CITY OF MT. MORRIS
PLANNING COMMISSION AGENDA
November 29th, 2021
6:30 p.m.

TO: City of Mt. Morris Planning Commission
FROM: Jason Ball, Senior Planner
Doug Skylis, Senior Project Manager
SUBJECT: 643 Walker Street and 630 West Mt. Morris Street
Conditional Use Application Review #2
DATE: November 23, 2021

This is a second review of an application to establish an adult use marijuana establishment on two separate parcels located at 643 Walker Street and 630 West Mt. Morris Street, parcel numbers 57-125-28-015 and 57-125-28-014. Ordinance Number 2021-03 requires an application for a Conditional Use Permit and submission for Site Plan Review for all marijuana establishments. Analyses of the request's compliance with City of Mt. Morris Zoning Ordinance provisions related to Conditional Uses, Site Plan Review, the regulation of marijuana establishments, and engineering and design components were completed on an original set of drawings submitted on October 13, 2021, for which ROWE provided a review letter on November 1, 2021, and a second set of drawings submitted November 19, 2021. Following is an update to the original review letter, with comments that were addressed by the applican

SUBMITTALS	
REVISIONS:	
	11/18/2021
	PROJECT NO.
	DATE
	08/26/2021
	SCALE
	NOTED
	SHEET TITLE
	- PROPOSED FIRE ESCAPE
	ROUTE
	- PROPOSED SECURITY PLAN
	A-05
	SEAL

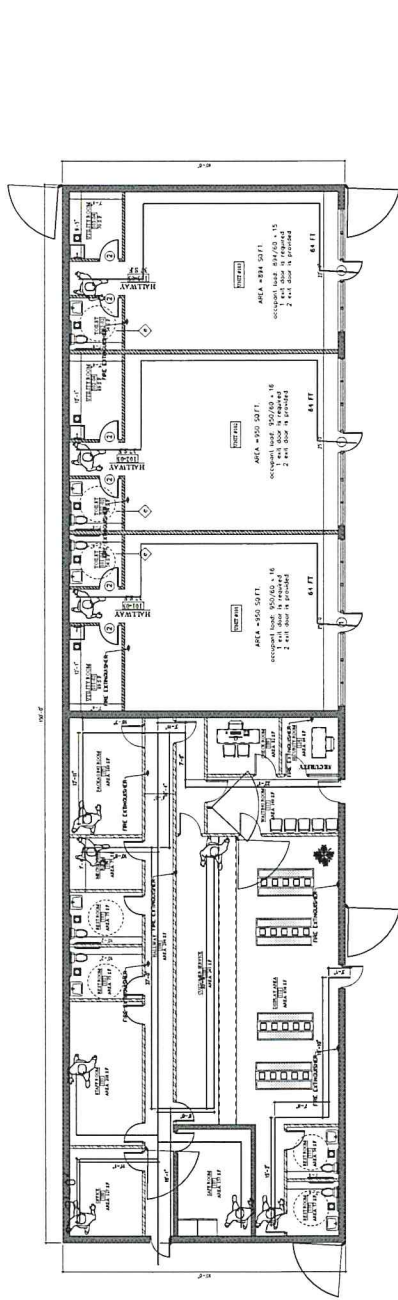
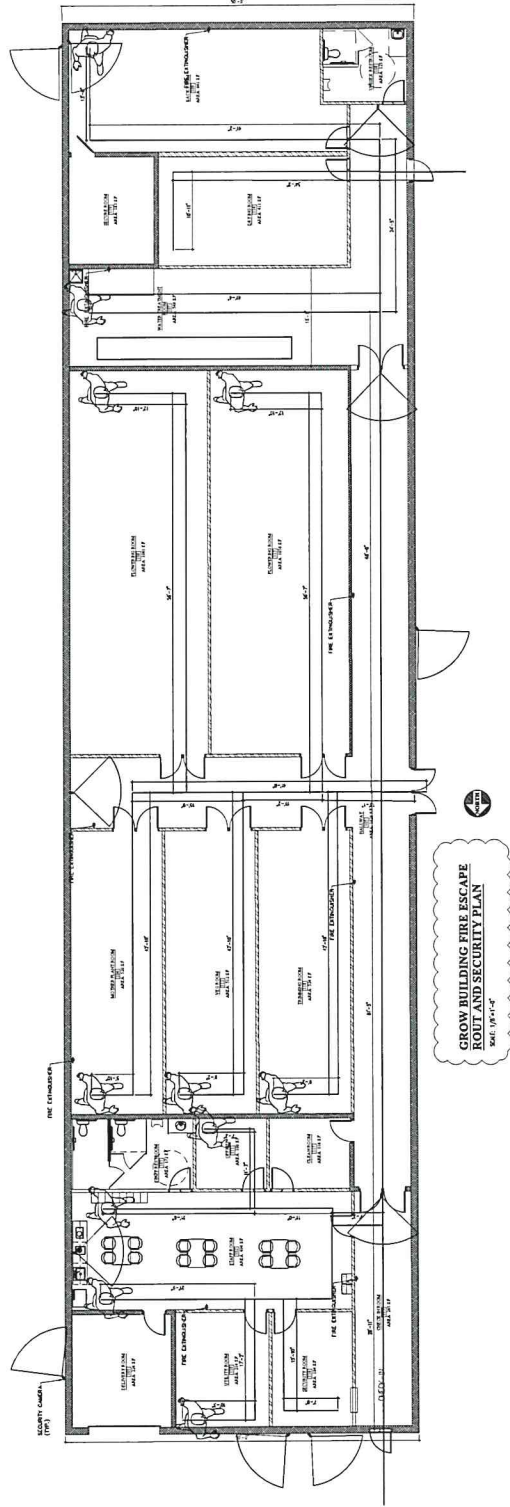
- ~~Clearly these are two different buildings yet the titles under each of them are the same. This needs to be corrected to confirm which building the title apply towards. Building title has been revised.~~
- The applicant will be required to submit for and obtain approval from Genesee County Drain Commissioner's office for storm water drainage, water, and sanitary sewer services. **To be addressed with engineering plan review.**

PROPOSED SITE PLAN
SCALE: 1"=40'-0"

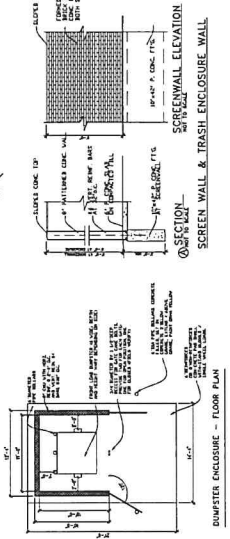
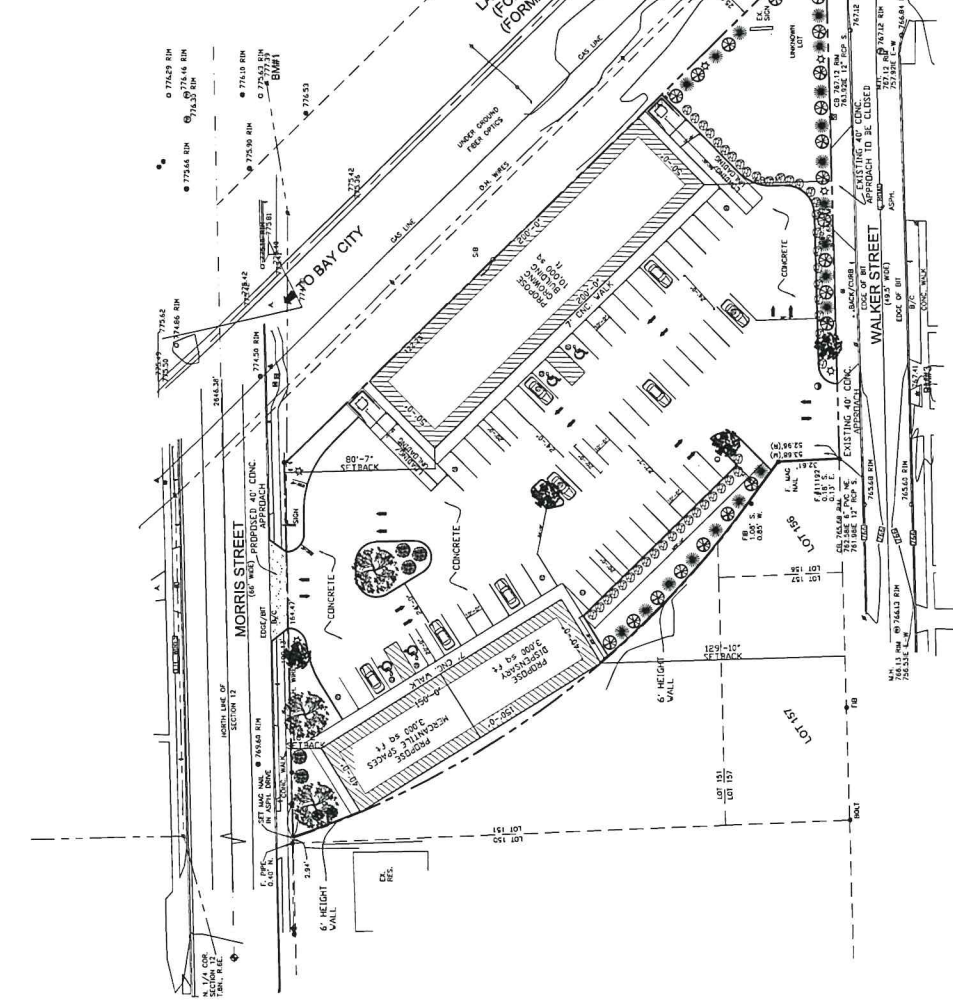
- The proposed concrete approach onto Morris Street shall be a Michigan Department of Transportation (MDOT) Type "M" opening where the gutter pan is constructed through the drive opening. **Comment has not been addressed.**
- ROWE questions the practicality of constructing the proposed buildings directly on the property line. How will the buildings be constructed without using the adjacent property? **Comment has not been addressed.**

- Sidewalk is required to be removed and replaced for the proposed drive approach. Additionally, the sidewalk shall be constructed through the drive approach and shall meet all Americans with Disabilities Act (ADA) requirements. **Comment has not been addressed.**

- The city will need to determine if sidewalk is required along the Walker Street frontage.
- The plan indicates the existing approach on Walker Street will be closed. This drive approach shall be removed, and the curb and gutter restored across the opening. **Comment has not been addressed.**

- ~~The city requires the parking lot to have curb and gutter. Curb lines have been added.~~
- This plan is deficient on dimensions indicating distances between parking and building areas, parking space sizes, and general layout data. Dimensions have been added.

- ROWE questions why the applicant is proposing to cover nearly the entire site with pavement. It would appear vehicle circulation could be better defined resulting in less pavement/impervious surface and creating more opportunities to promote storm water infiltration areas resulting in less storm water runoff. Proposed pavement area has been reduced.

- The proposed barrier-free parking spaces also require appropriate signs. Sign locations and details shall be provided. **Comment has not been addressed.**

- It appears there are multiple doorways in each of the proposed buildings which open outward onto the proposed sidewalk. ROWE questions if the proposed sidewalk should have stoops with frost-free footings to prevent the sidewalk from heaving and interfering with the doors. **Comment has not been addressed.**
